<b>LEXINGTON-FAYETTE URBAN COUNTY GOVERNMENT CONTRACT CHANGE ORDER</b> Page 1 of 2	Date:	November 17, 2015	
	Project:	Hartland Pump Station Improvements	
	Location:		
To (Contractor): Kenney, Inc.	Contract No.	268-2015	
	Original Contract Amt.	\$142,600.00	
	Cumulative Amount of Previous Change Orders	\$0.00	
	Percent Change - Previous Change Orders		0.00%
	Total Contract Amount Prior to this Change Order	\$142,600.00	
	Change Order No.	1

PROJECT: Hartland Pump Station Improvements

CHANGE ORDER: #1

**PROPOSAL No. 1A - COMPLETE PUMP DISCHARGE PIPING FROM NEW PUMP BASE & TIE-IN AT EXISTING FORCE MAIN CONNECTION. ADD CROSS OVER CONNECTION AS SHOWN IN PROPOSED DRAWING.**

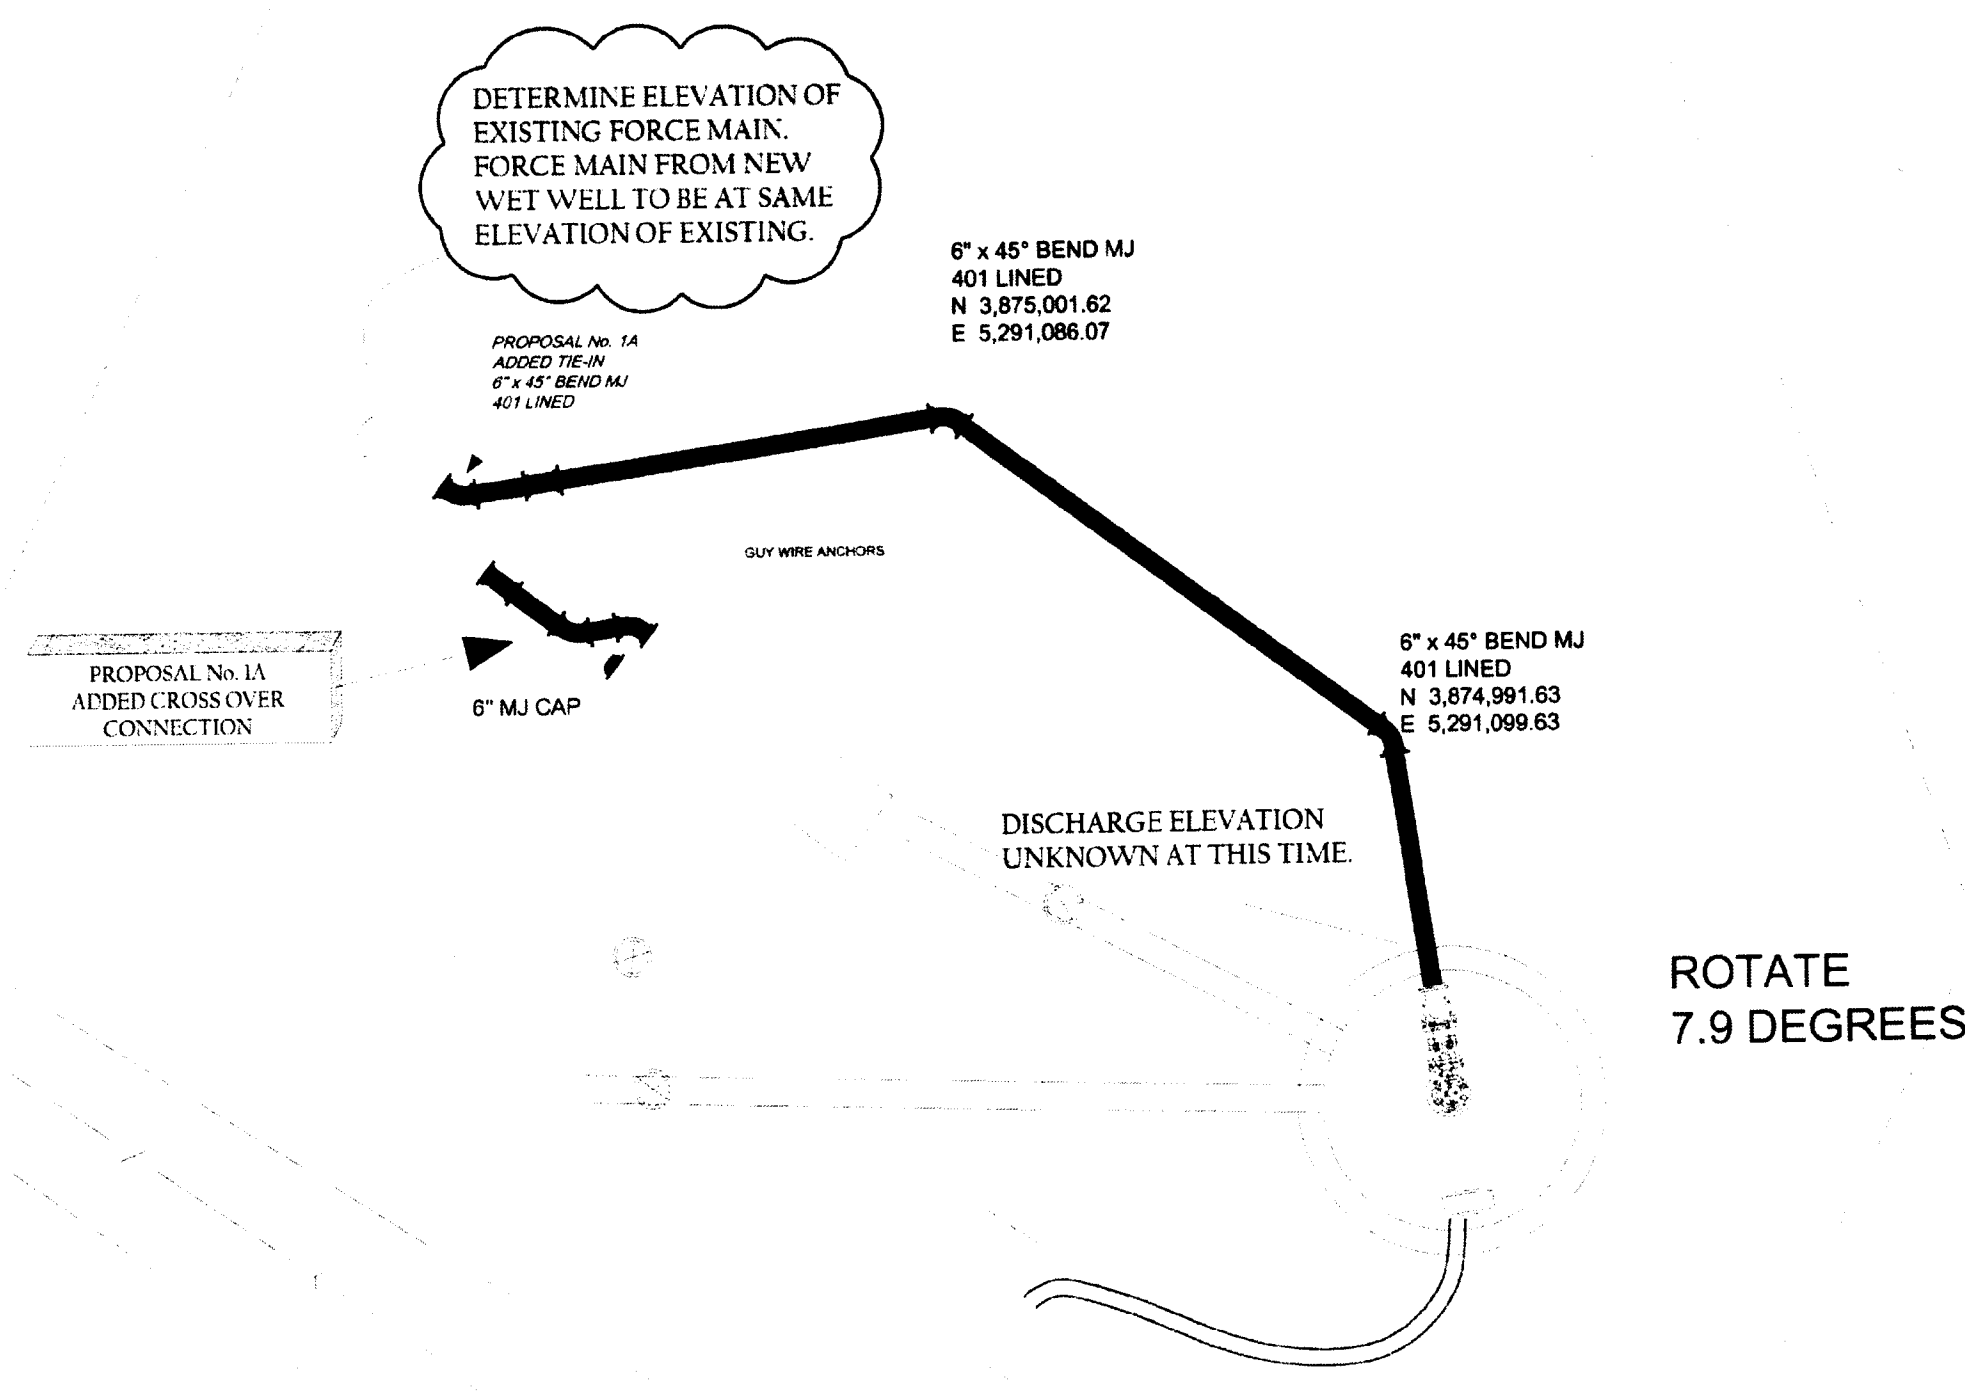
DETERMINE ELEVATION OF  
EXISTING FORCE MAIN.  
FORCE MAIN FROM NEW  
WET WELL TO BE AT SAME  
ELEVATION OF EXISTING.

DISCHARGE ELEVATION  
UNKNOWN AT THIS TIME.

ROTATE  
7.9 DEGREES

DETERMINE ELEVATION OF  
EXISTING FORCE MAIN.  
FORCE MAIN FROM NEW  
WET WELL TO BE AT SAME  
ELEVATION OF EXISTING.

PROPOSAL No. 1A  
ADDED TIE-IN  
6" x 45° BEND MJ  
401 LINED

PROPOSAL No. 1A  
ADDED CROSS OVER  
CONNECTION

DISCHARGE ELEVATION  
UNKNOWN AT THIS TIME.

ROTATE  
7.9 DEGREES

# HARTLAND No. 1 PROPOSED DISCHARGE PIPING CHANGE

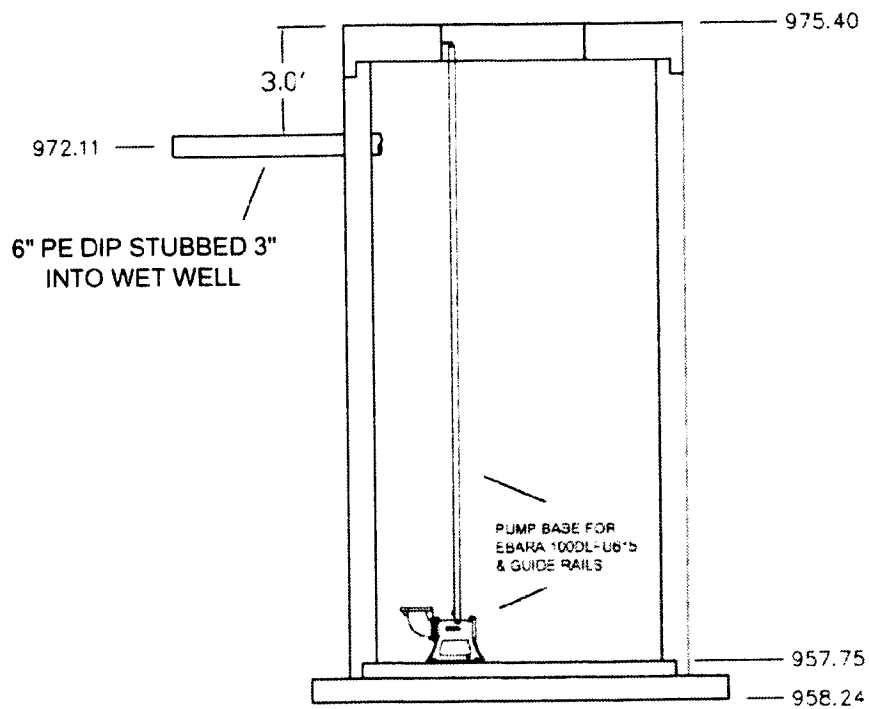
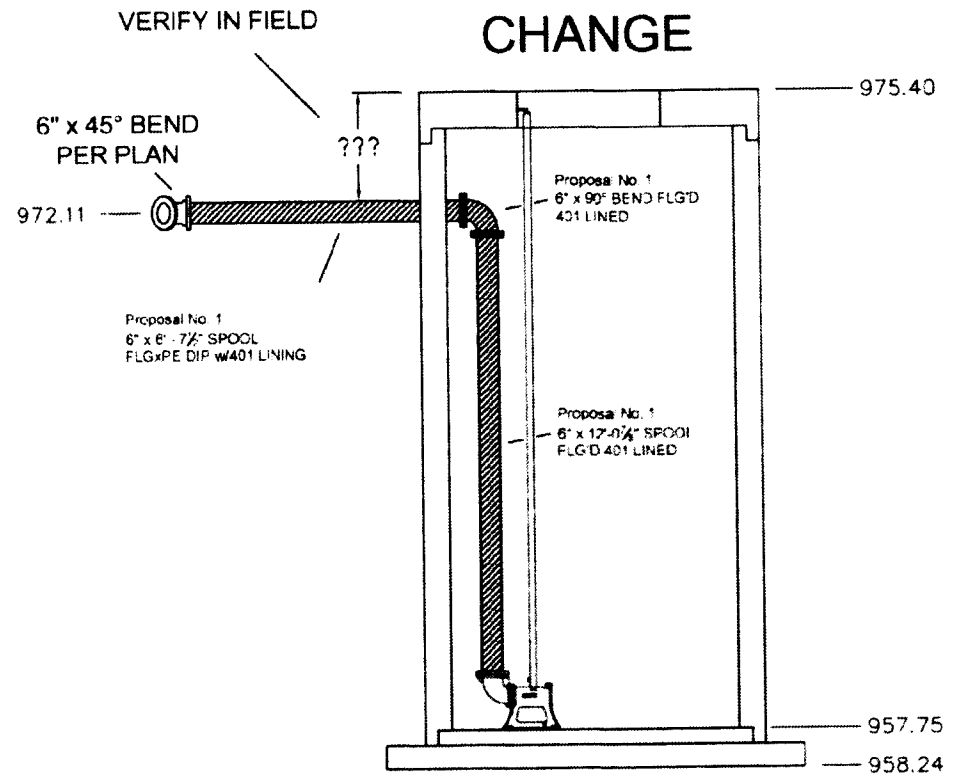
## ORIGINAL PLAN

## PROPOSED CHANGE
